Survey Report

Name 2010-07.1 Vegetation Management | FAC-003-4

1. Do you agree with the FAC-003-4 table 2 MVCD values? If not, please provide your response below.

2. Do you agree with modifying the elevation levels in table 2 to go up to 15,000 feet and 4,267 meters? If not, please provide your response below.

Figure 1

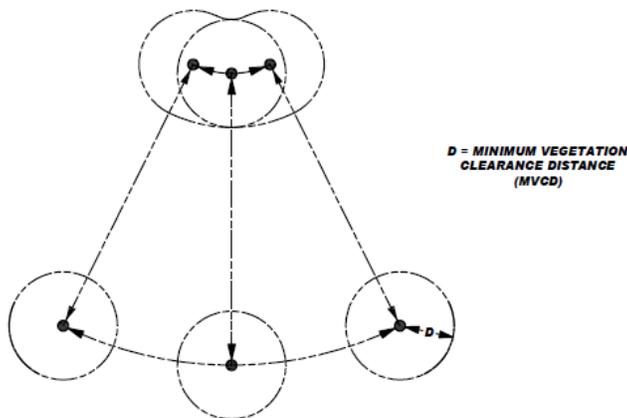
Commented [MB30]: This gets to the point that we should be saying the vegetation cannot encroach on the area defined by all possible conductor movement plus the MVCD around that area.
